Appendix A: Request for Variance

Infrastructure Standards for Telecommunications Spaces v4.0

Request Date:	9/12/24
Government POC:	Tim Stark
Org Represented:	Castle Point VA Medical Center
Email Address:	Timothy.Stark@va.gov
Contact Phone:	914-776-4654
Site, Building #, Room, Mission of the Facility Where Requested (also note admin vs medical specific use):	Castle Point VA Medical Center B.15E - TR 011A & TR 315 B.16 - TR F100 B.17 - TR G-203 B.18 - TR 39
Variance Requested:	B.15E & B.15H - TR 011A serves both Buildings 15E and 15H. While technically separate buildings, 15E/H share corridors and exterior walls. There is ample coverage provided from a single TR serving both buildings. B.15E & B.15H - TR 315 serves attic. There is limited programming space on the 4th floor (attic); 3rd floor TR has sufficient capacity to serve any anticipated service needs in the attic. B.16 - TR F100 serves 2nd and 3rd floors. There is limited space available on the 2nd and 3rds floors due to programming needs. It is anticipated that ~75-100 ports are needed for the 1st, 2nd, and 3rd floors combined, which can be served appropriately from a single rack in F100. B.17 - TR G-203 serves the 2nd and 3

1 LEVEL 00 - FLOOR PLAN
1/16" = 1'-0"

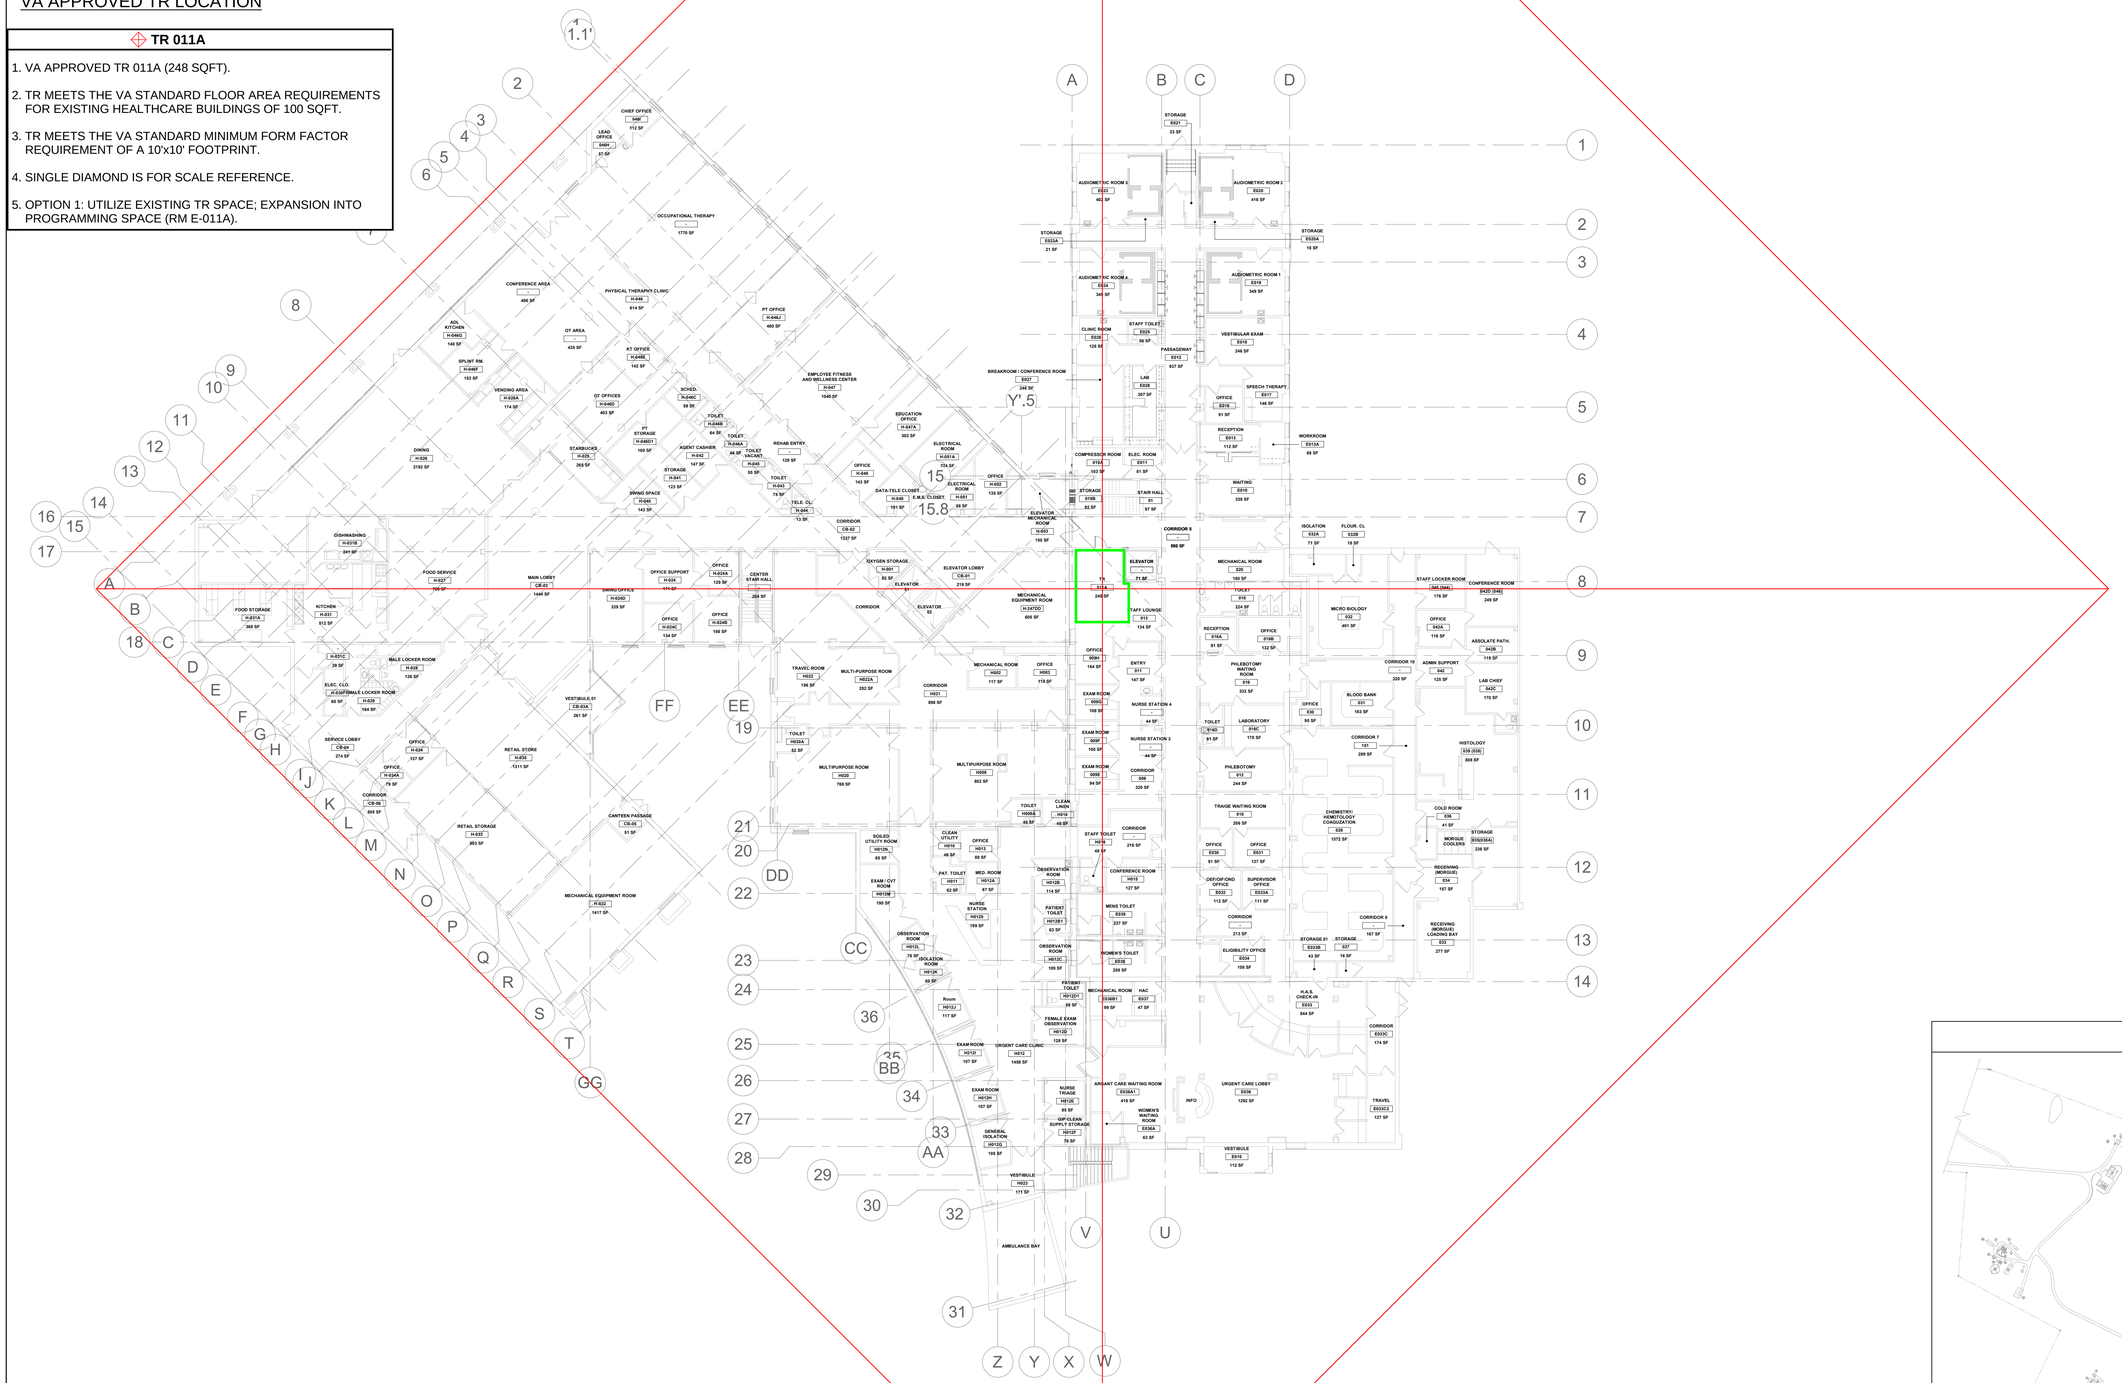
1. VA APPROVED TR 011A (248 SQFT).
2. TR MEETS THE VA STANDARD FLOOR AREA REQUIREMENTS FOR EXISTING HEALTHCARE BUILDINGS OF 100 SQFT.
3. TR MEETS THE VA STANDARD MINIMUM FORM FACTOR REQUIREMENT OF A 10'x10' FOOTPRINT.
4. SINGLE DIAMOND IS FOR SCALE REFERENCE.
5. OPTION 1: UTILIZE EXISTING TR SPACE; EXPANSION INTO PROGRAMMING SPACE (RM E-011A).

1 LEVEL 01 - FLOOR PLAN
1/16" = 1'-0"

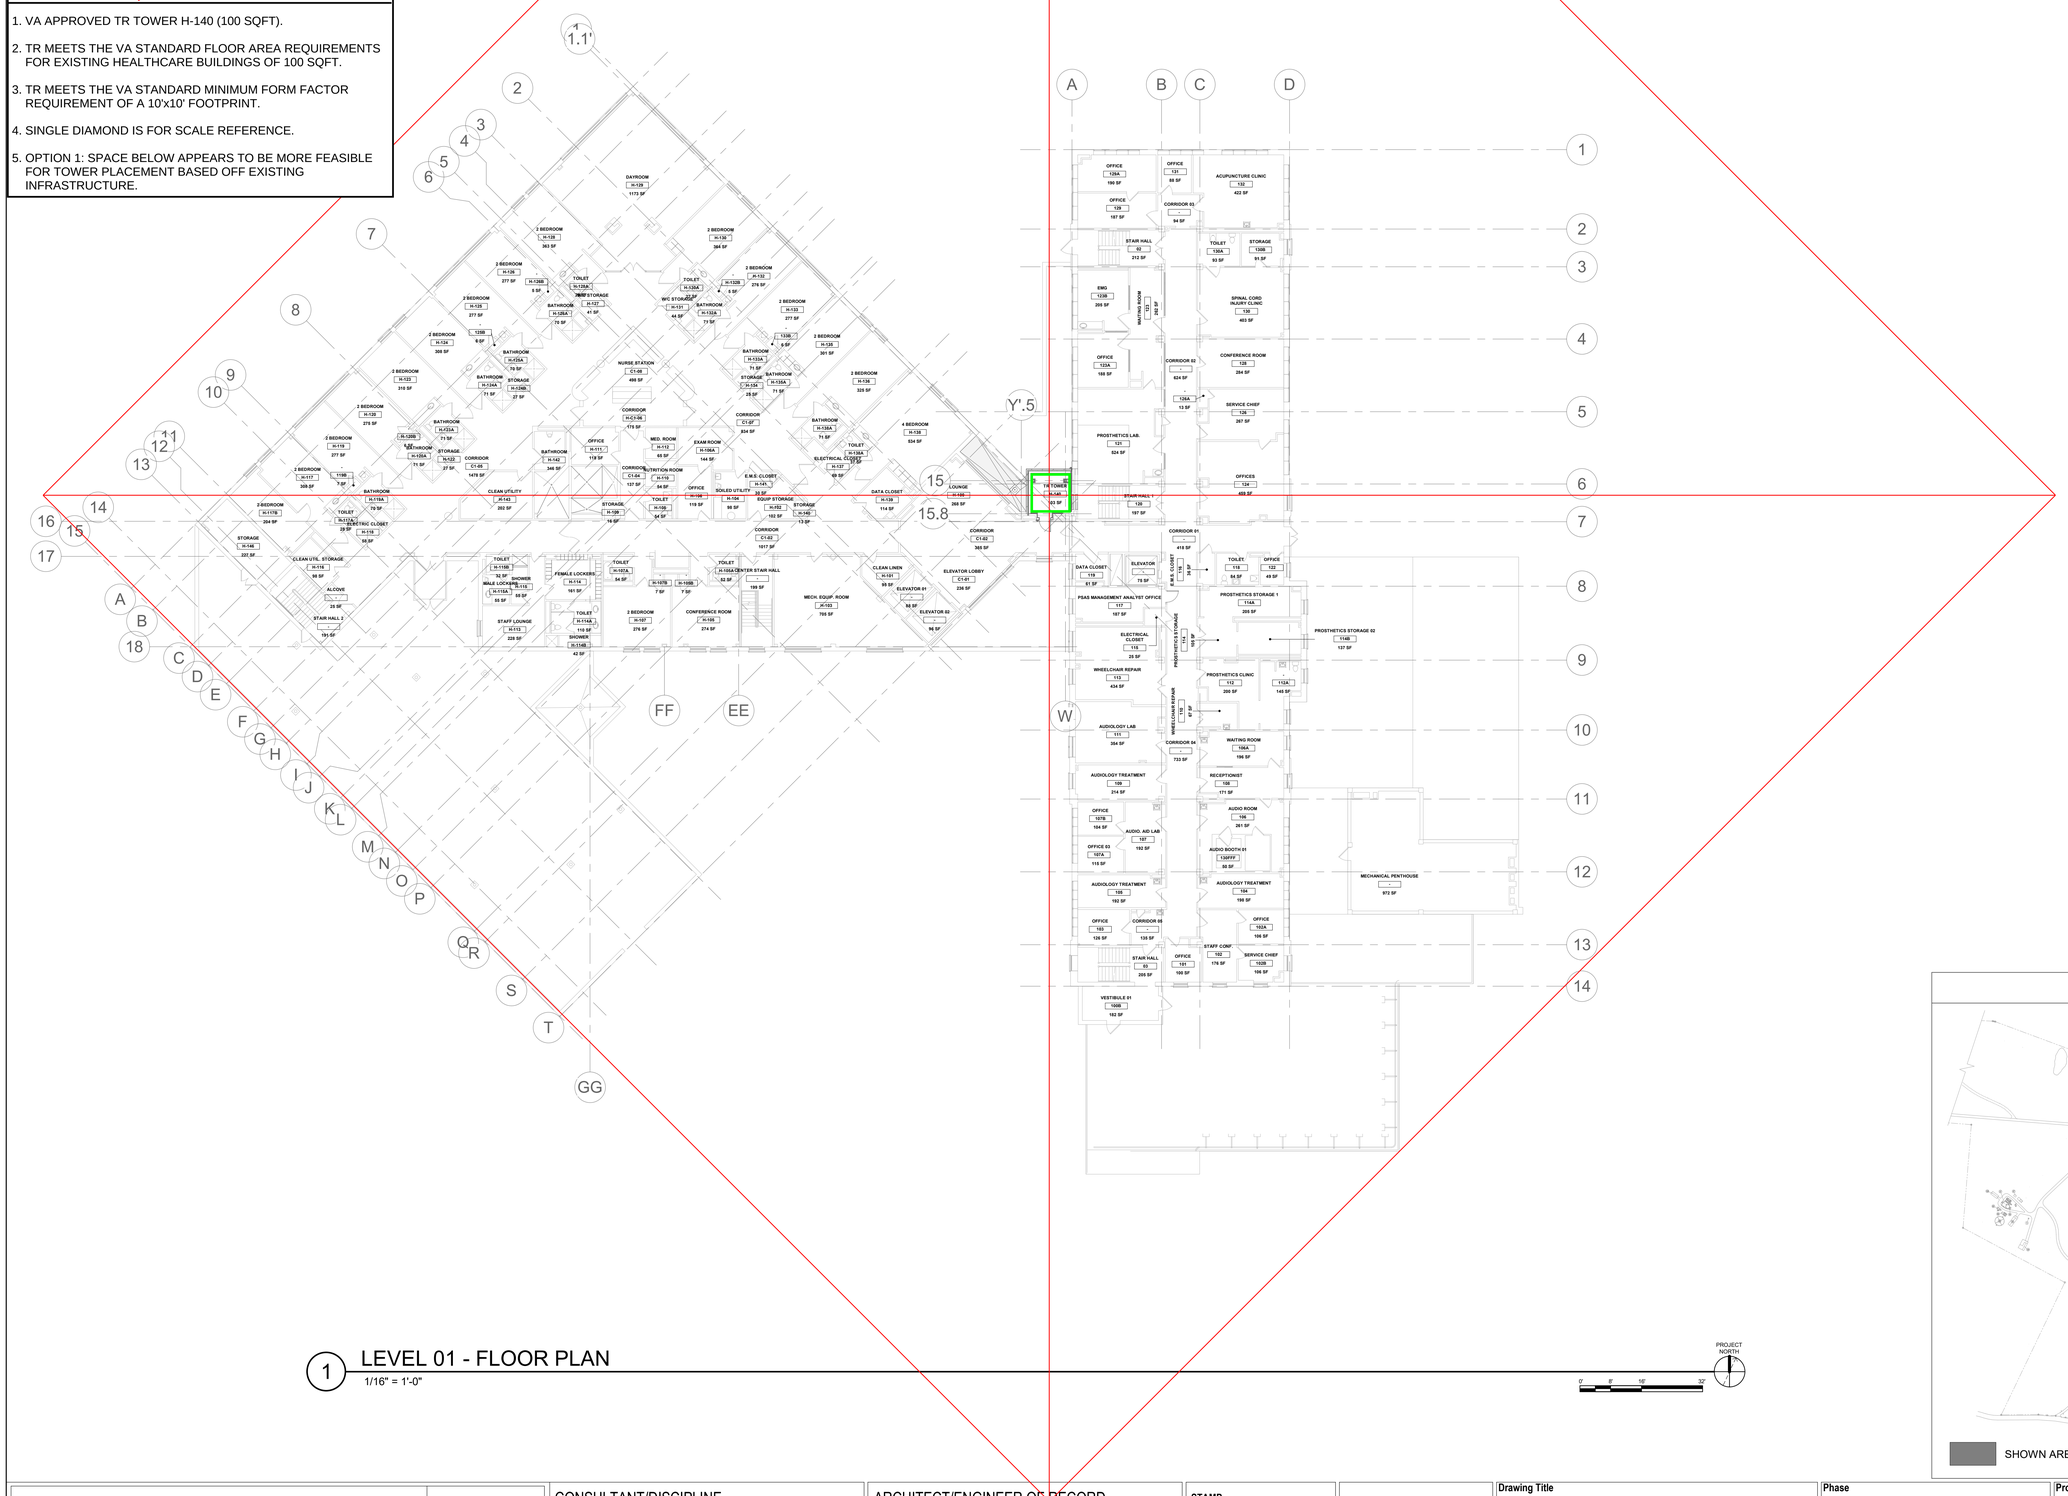
1. VA APPROVED TR TOWER H-140 (100 SQFT).
2. TR MEETS THE VA STANDARD FLOOR AREA REQUIREMENTS FOR EXISTING HEALTHCARE BUILDINGS OF 100 SQFT.
3. TR MEETS THE VA STANDARD MINIMUM FORM FACTOR REQUIREMENT OF A 10'x10' FOOTPRINT.
4. SINGLE DIAMOND IS FOR SCALE REFERENCE.
5. OPTION 1: SPACE BELOW APPEARS TO BE MORE FEASIBLE FOR TOWER PLACEMENT BASED OFF EXISTING INFRASTRUCTURE.

1 LEVEL 02 - FLOOR PLAN
1/16" = 1'-0"

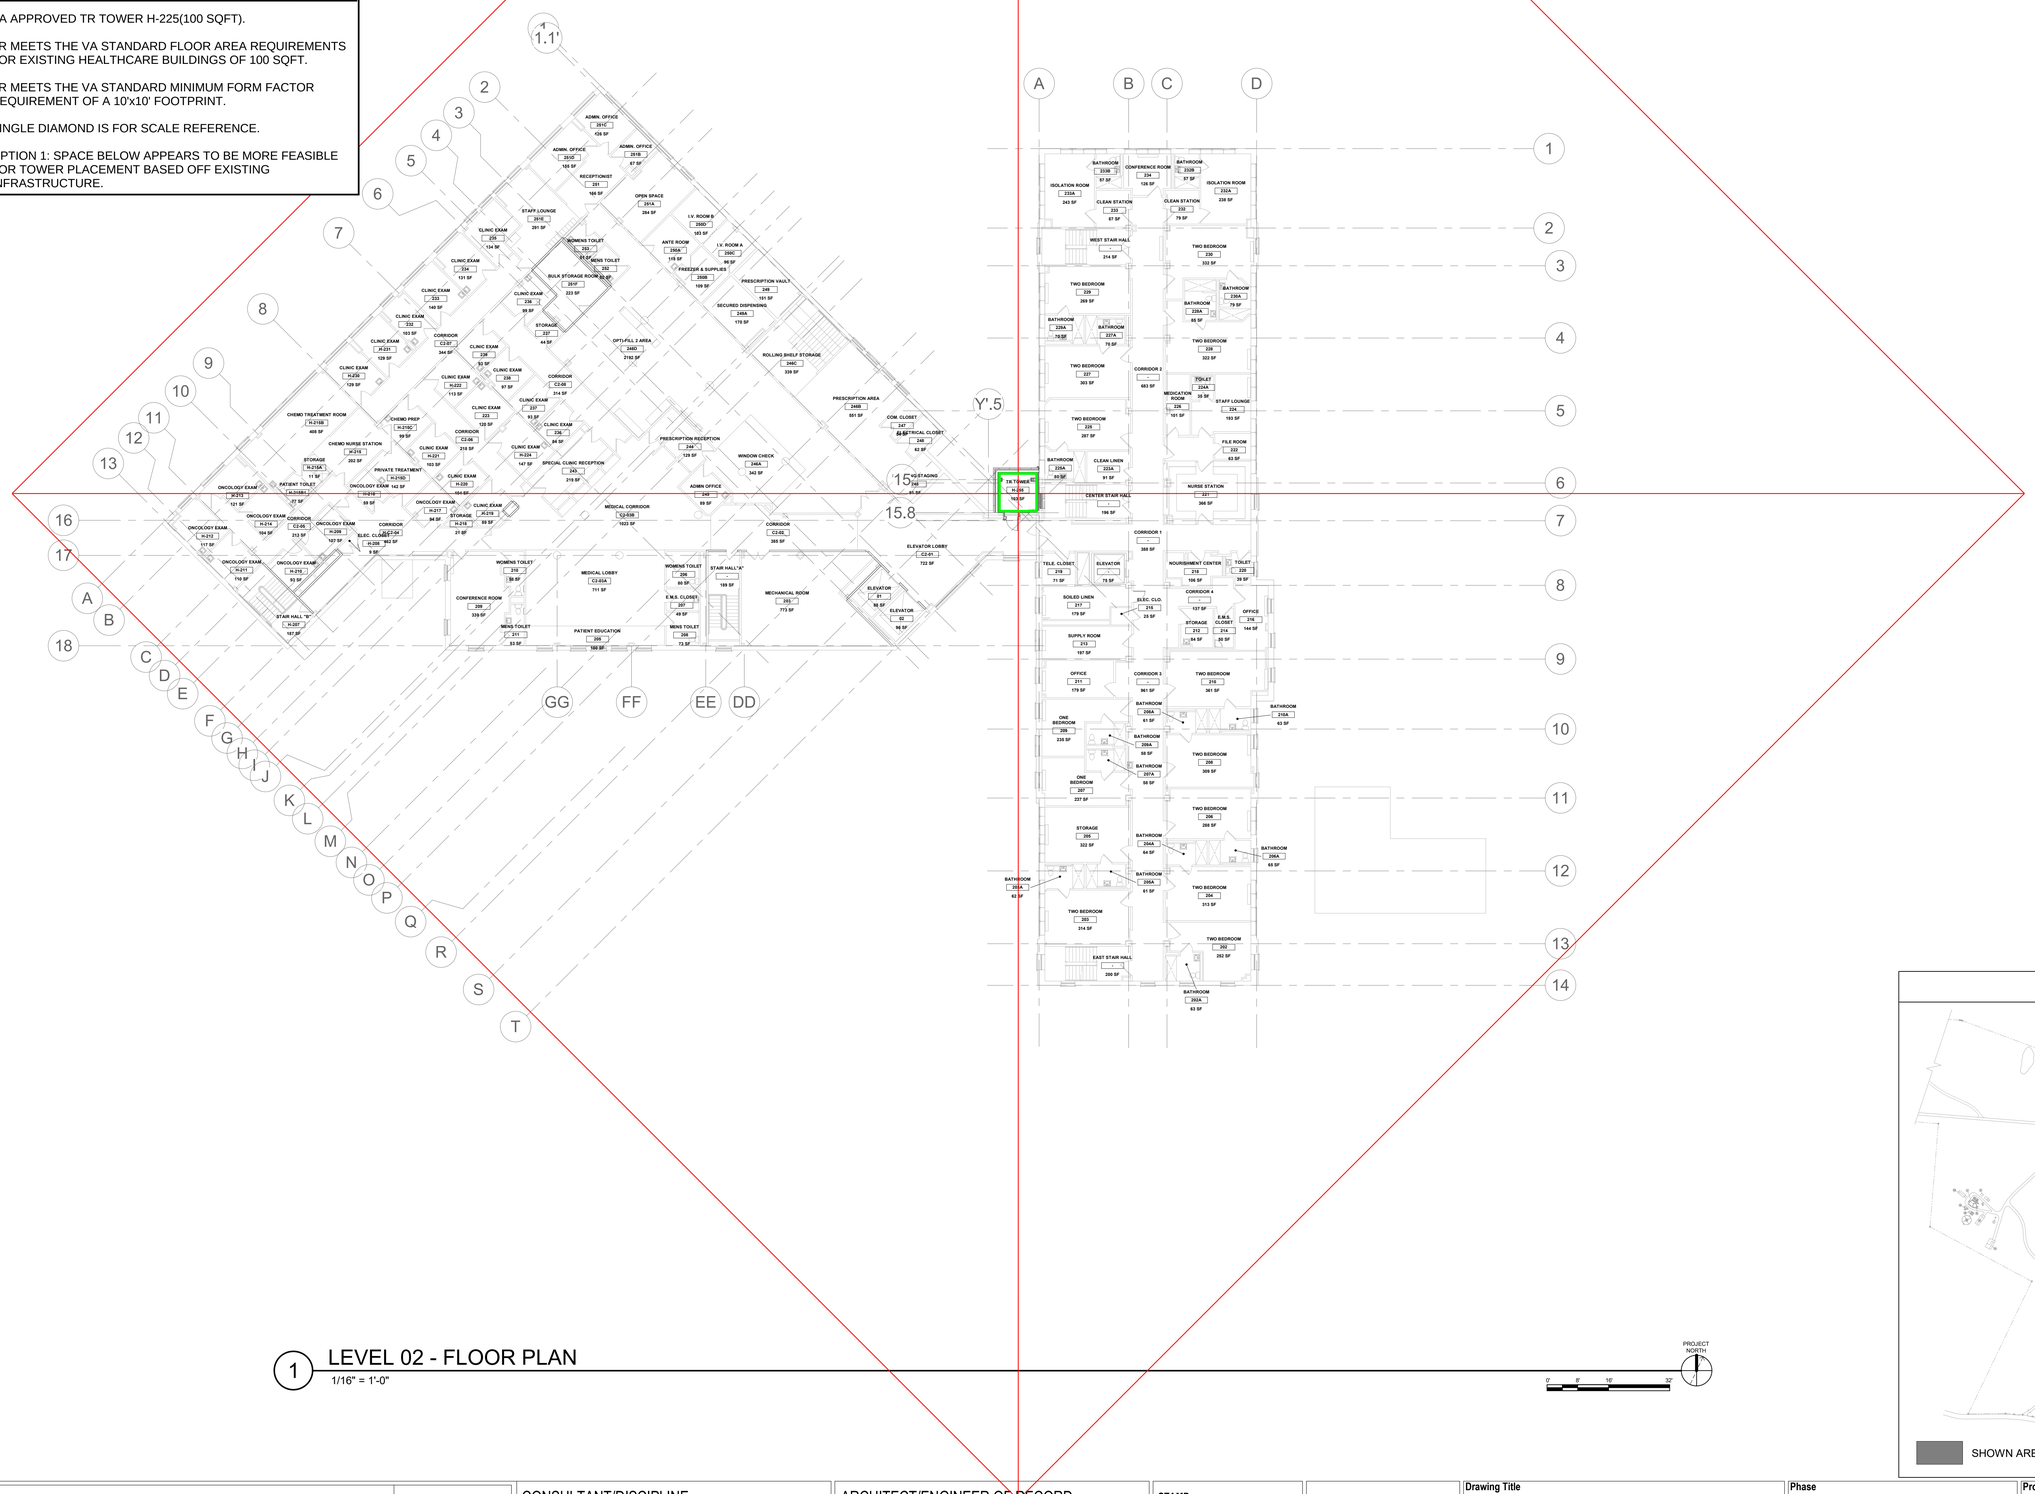
1. VA APPROVED TR TOWER H-225(100 SQFT).
2. TR MEETS THE VA STANDARD FLOOR AREA REQUIREMENTS FOR EXISTING HEALTHCARE BUILDINGS OF 100 SQFT.
3. TR MEETS THE VA STANDARD MINIMUM FORM FACTOR REQUIREMENT OF A 10'x10' FOOTPRINT.
4. SINGLE DIAMOND IS FOR SCALE REFERENCE.
5. OPTION 1: SPACE BELOW APPEARS TO BE MORE FEASIBLE FOR TOWER PLACEMENT BASED OFF EXISTING INFRASTRUCTURE.
